UPPER TRISHULI-1 HEP (216MW)			
Client	Doosan Heavy Industries & Construction		
DHI’s Subcontractor	Power Construction Corporation of China		
REPLY COMMENT			
Subcontractor	Power Construction Corporation of China		
Incoming Document			
Title of the Document	Excavation and Initial Support Drawings of Investigation Tunnel for Powerhouse		
Document/Drawing No.	UT1-C-385-CVL-DG-65002-01 to 04	Revision	A
Review Document No.	TJ/UT1/OUT-12	Reviewed Note No.	RN-0053
Received Date	04.02.2022	Review status	AN
Outgoing Document			
Previous Reply No.	XXX	Previous Reply Date.	31.01.2022 2
Reply No.	RC-000X	Reply date	04.06.2022 2

Drawing UT1-C-385-CVL-DG-65002-03, Rev. D

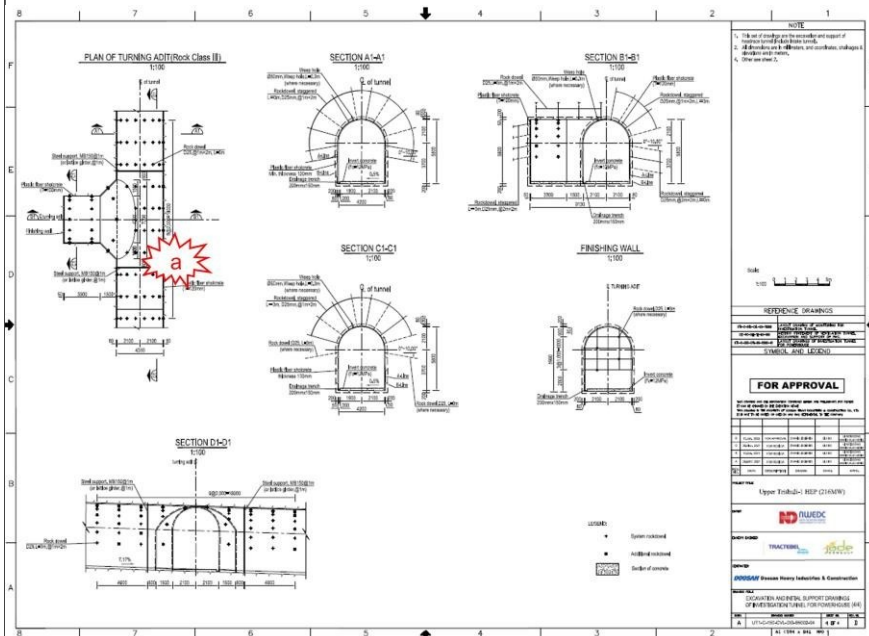
a) Do not connect the support type with overburden thickness. Use one thickness in Class IV (120 mm, C25).

Reply□This item has been modified by referring to similar file, i.e.: UT1-C-090-CVL-DG-64002-01 to 06 EXCAVATION AND SUPPORT OF ACCESS TUNNEL TO POWERHOUSE.
